Permit Application No.: **18-002**

Rules: **Erosion Control, Wetland Protection, & Stormwater Management**

Applicant: **Wally Marx**
Project: **6 Lot Residential Subdivision**
Location: **2500, 2700, 2702, and 2900 Parkview Drive, Medina**

**SCHOOL LAKE NATURE PRESERVE
WETLAND BUFFER EXHIBIT A**

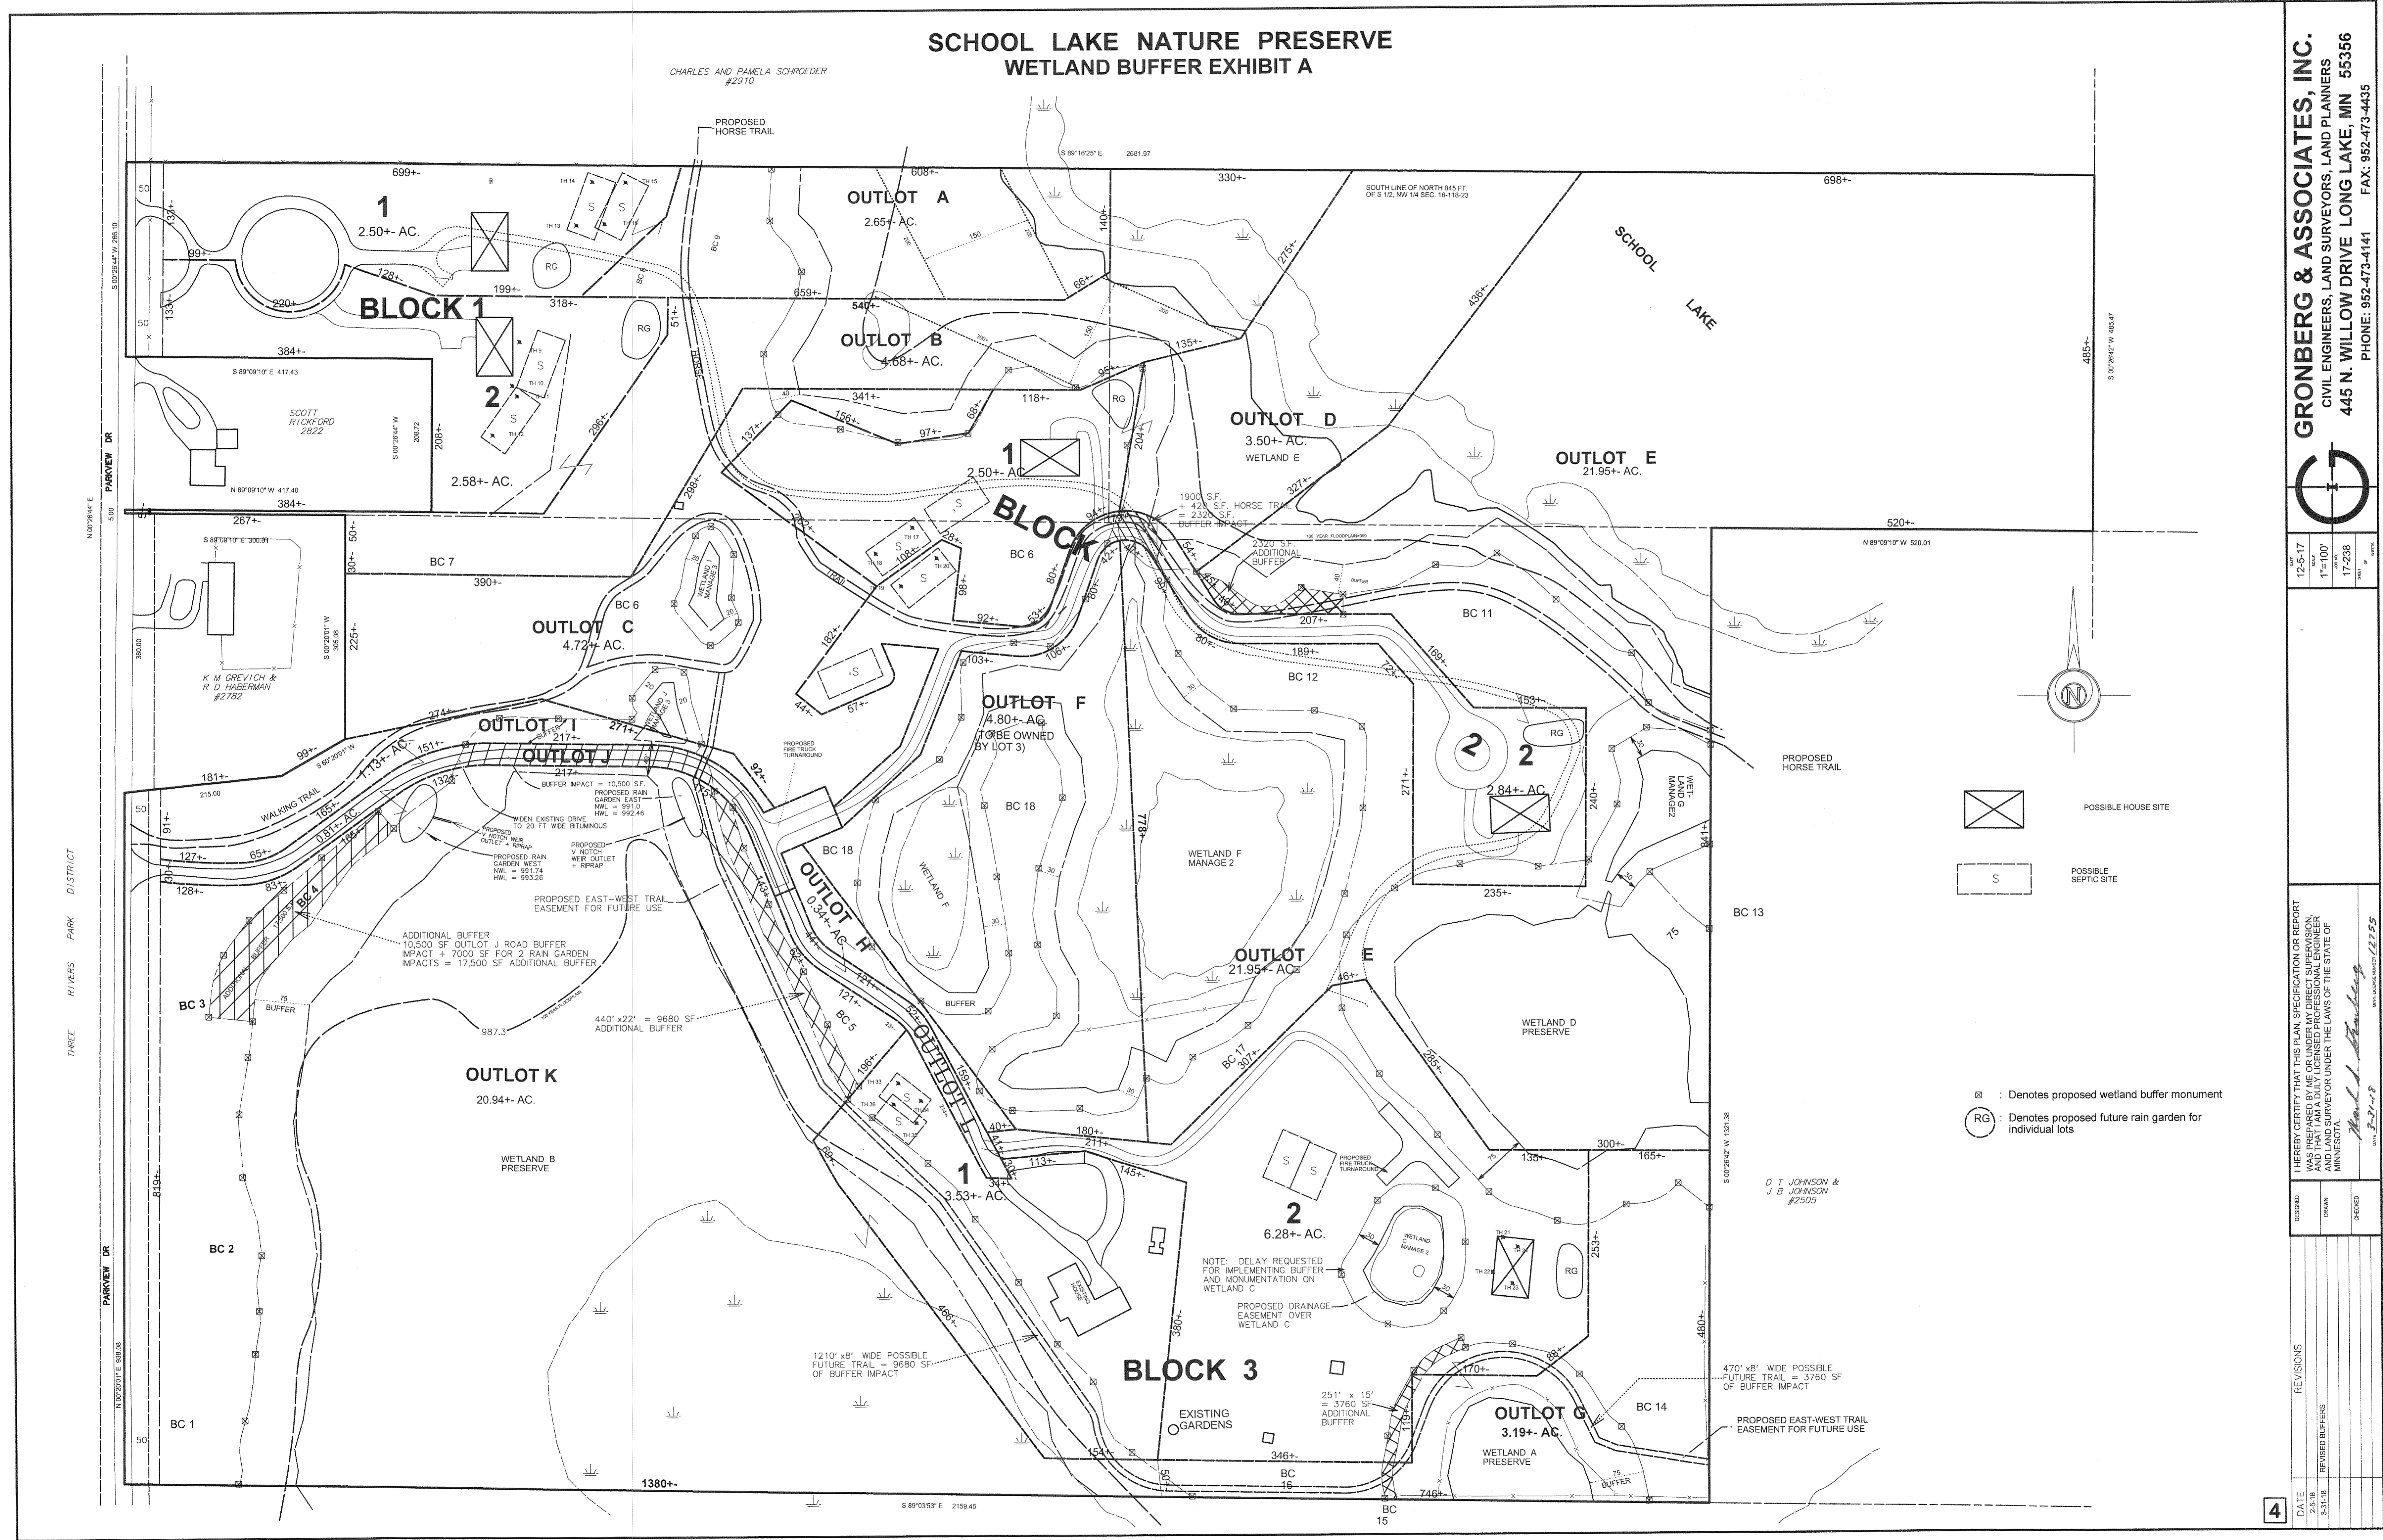
A trail of 3760 square feet is proposed around Wetland A which is compensated for by the addition of 3,760 square feet of additional buffer. A trail and raingardens are proposed in the buffer for Wetland B, which are compensated for through the addition of 16,680 square feet of additional buffer. Raingardens require frequent maintenance and often involve vegetation and management practices inconsistent with the wetland buffer vegetation requirements, and were therefore excluded from the buffer area. The minimum buffer width required under Section 6(c) is not met on Wetland B, Wetland E, Wetland F, and Wetland J, prompting the applicant’s request for a variance, which is addressed below.

The applicant has submitted a signed variance application requesting a variance from compliance with the minimum buffer requirements. The proposed activities include buffer that falls short of the required minimum at four points on the property: The variance includes a 17.5 foot shortfall from the 37.5-foot minimum buffer requirement when employing buffer averaging for Wetland B on Outlot J and K, a 2-foot shortfall from the 10-foot minimum buffer requirement when employing buffer averaging for Wetland J on Outlot I and J, a 7-foot shortfall from the 10-foot minimum buffer requirement when employing buffer averaging for Wetland F on

The first two shortfalls are requested for the main road on the property, which is required, by the City of Medina, to be widened from 16 feet to 20 feet to accommodate emergency vehicles. The second two shortfalls are requested for the construction of a new drive located on an existing trail. Due to the number of wetlands on the site, there are limited locations for access to the proposed lots. Alternative road locations would also not be in conformance with the minimum buffer width requirements. The total buffer area will be provided for Wetland B and Wetland E. The additional buffer area required for Wetland J and Wetland F will be provided on Wetland B and Wetland E, respectively. Wetlands J and B and Wetlands F and E are connected hydrologically through existing culverts and are considered to be part of the same wetland complexes.

Staff concurs in the factual statements and technical justifications stated above and in the variance application. Accordingly, staff finds there is an adequate technical basis and justification to grant the requested variances.

SCHOOL LAKE NATURE PRESERVE EROSION CONTROL PLAN

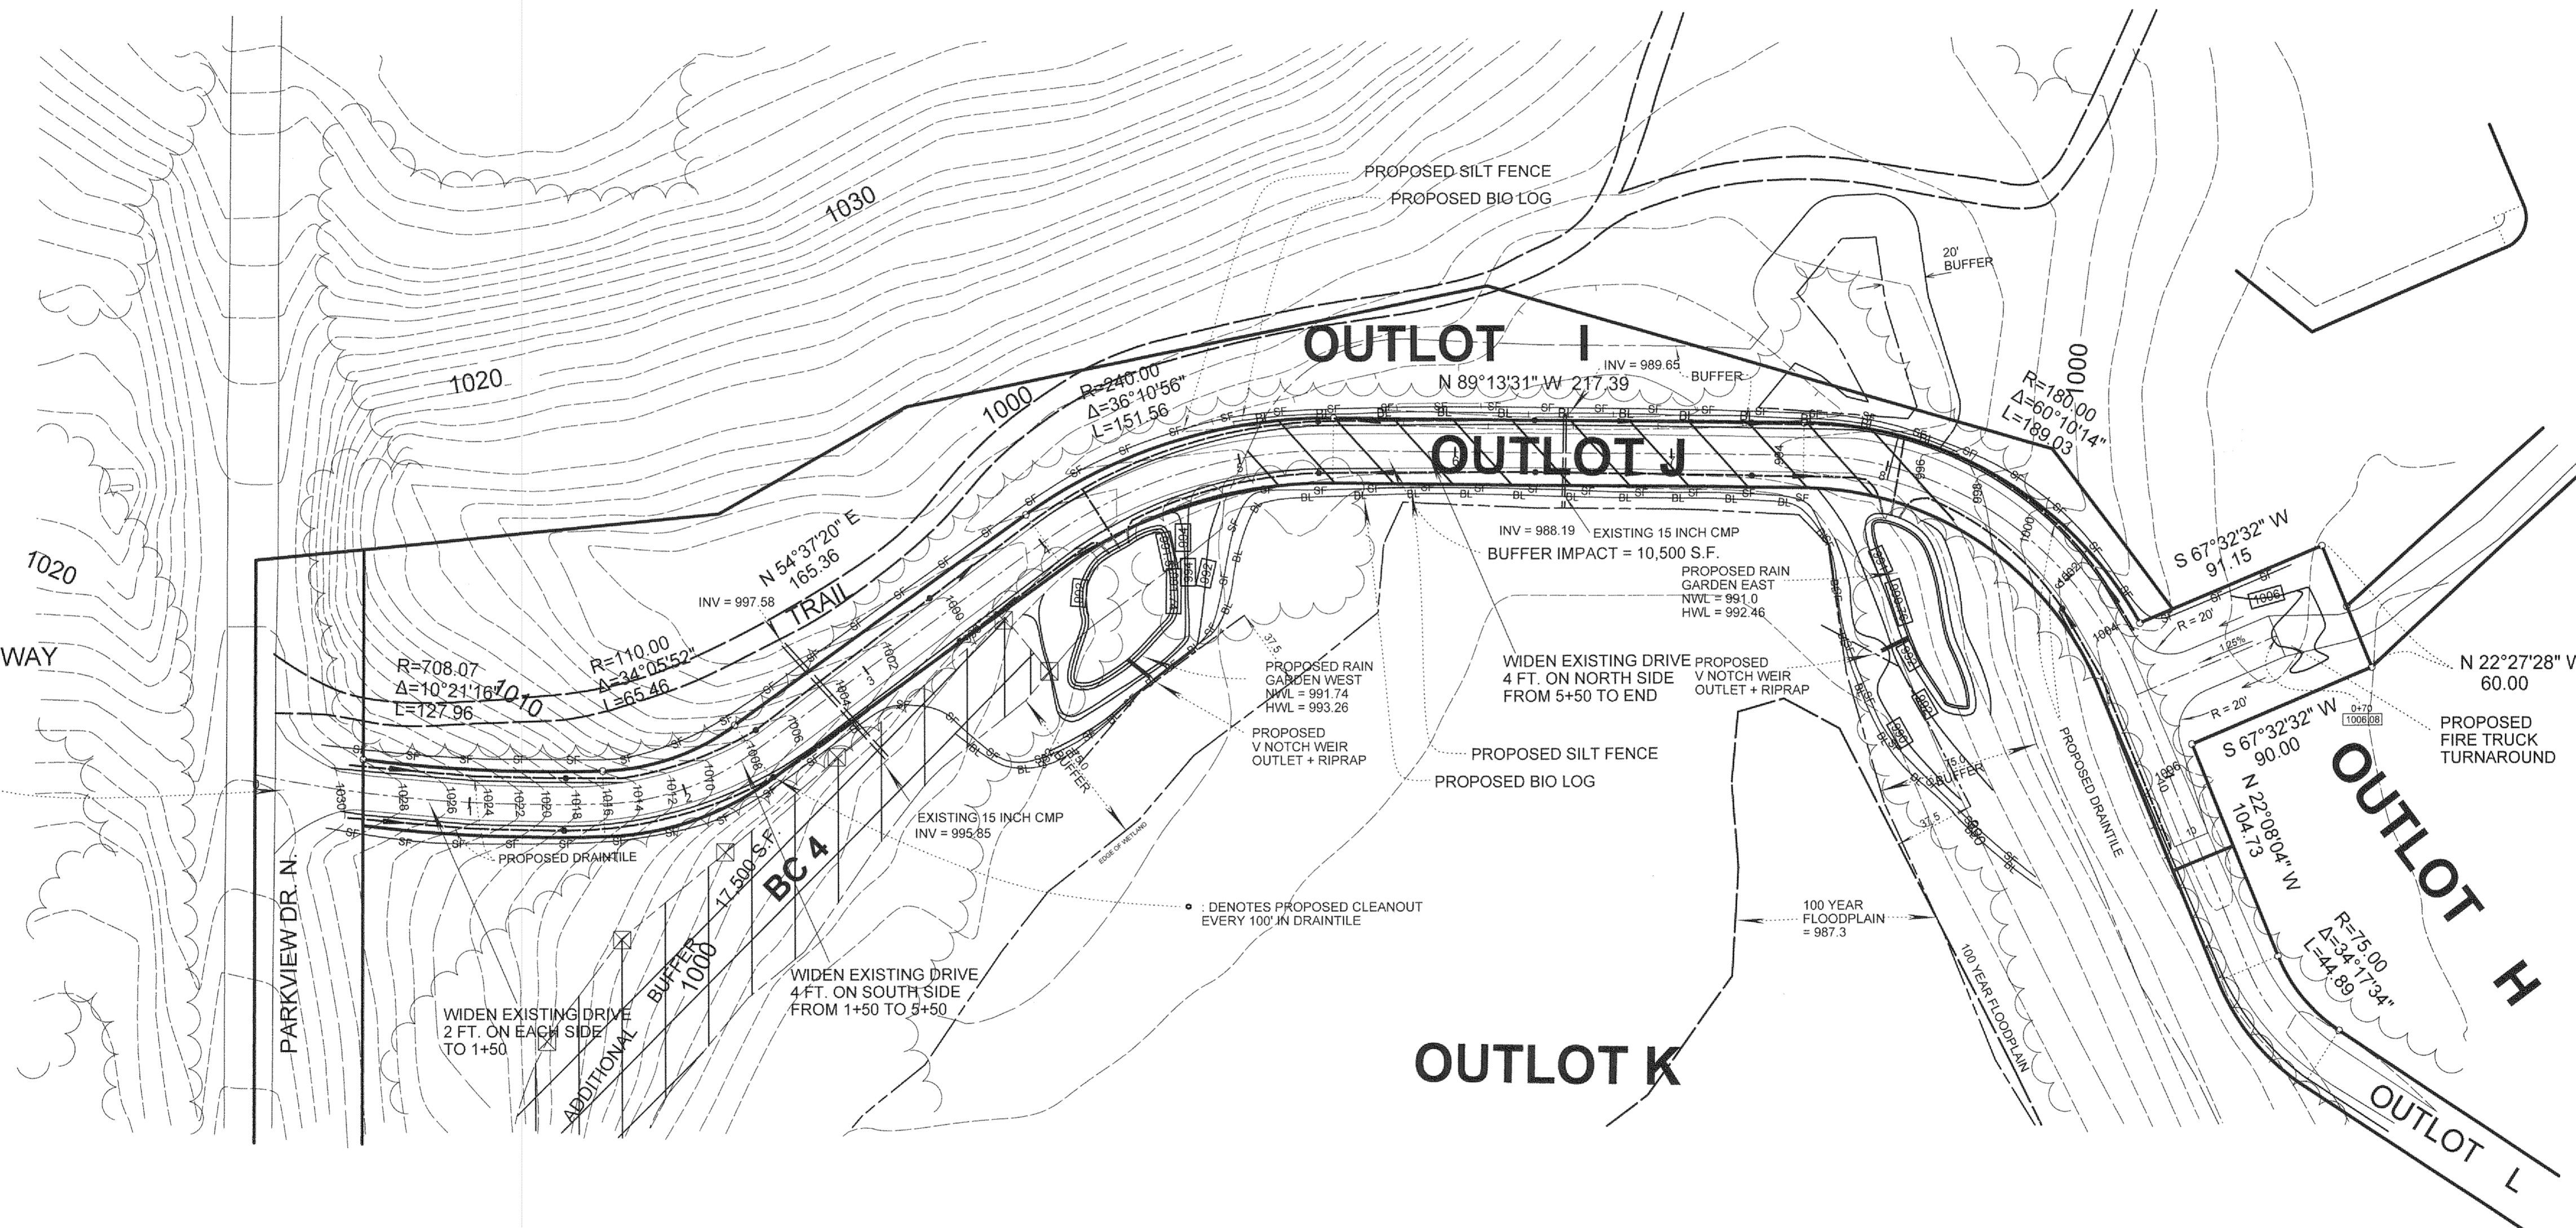
The Applicant has submitted an erosion control plan which provides best management practices to achieve erosion and sediment control including a rock construction entrance, silt fence and inlet protection where necessary. A vegetative stabilization plan including the incorporation of six-inches of topsoil into underlying soils prior to final stabilization has also been provided. The Project's concrete washout will be handled off-site. A

On resolution of the recommended condition, erosion control practices will meet District requirements.
